FINAL MINOR SUBDIVISION PLAN

LANCASTER FARM SANCTUARY

Re: Final Minor Subdivision Plan for Lancaster Farm Sanctuary
Our File No. 10221-1

Re: Lancaster Farm Sanctuary
Final Minor Subdivision Plan
Township Permit No. 25-17-MSDP
LCEC Project No: 25-205

SUBDIVISION PLAN

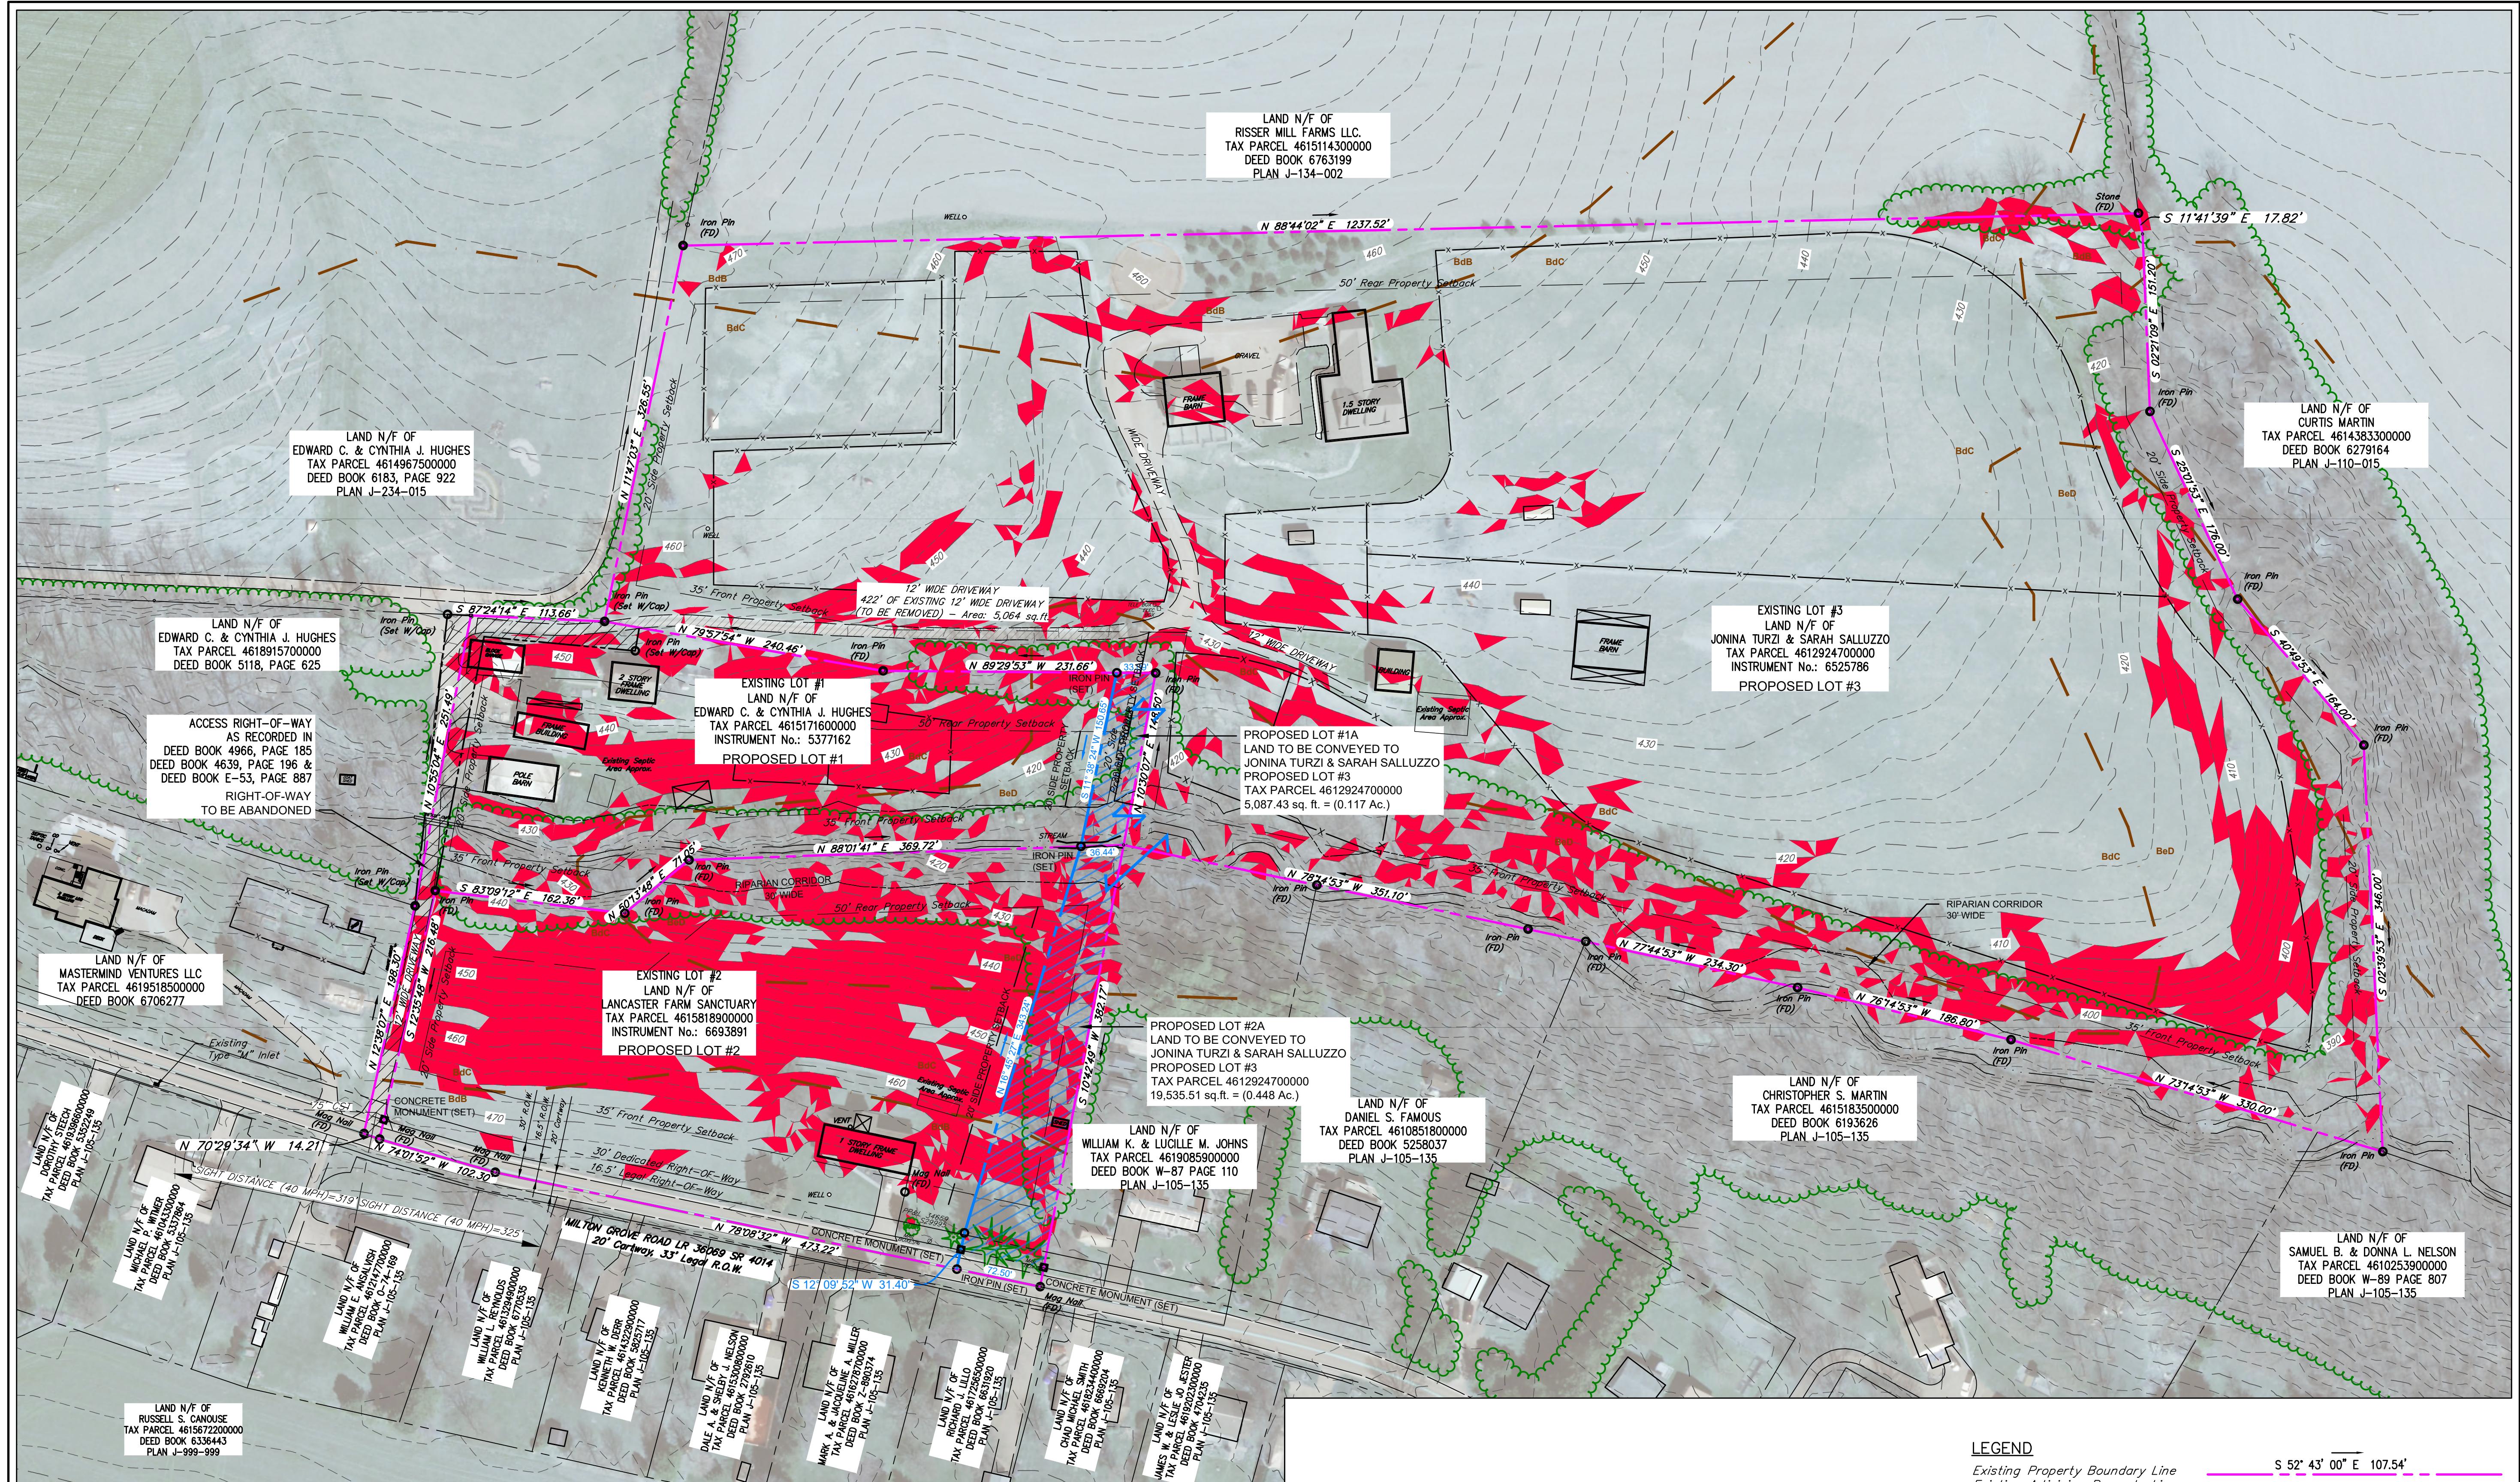
Sheet 2 of the Plan does not include tie bars to show the addition of Lot 1A from the Hughes Lot and Lot 2A from the Lancaster Farm Sanctuary Lot to become part of the Landlocked Lot. Sheet 2 of the Plan indicates that the Landlocked Lot (identified as Lot 3) will increase in size, so Lot 1A and Lot 1B are obviously to be added to the Landlocked Lot/Lot 3.

The Plan should be proofread. The recording reference of the deed for the Landlocked Lot is Document No. 6525786, not Deed Book 6525, Page 786. Similarly, the deed for the Hughes Lot is Document No. 5377162, not Deed Book 5377, Page 162. These corrections should be made on both the cover sheet and Sheet 2.

12. General Note #20 indicates that "there are no areas of this plan which are proposed for dedication to Mount Joy Township." However, Sheet 2 indicates that street right-of-way is proposed (119-35.E(2)(d)). This should be clarified on the plans.
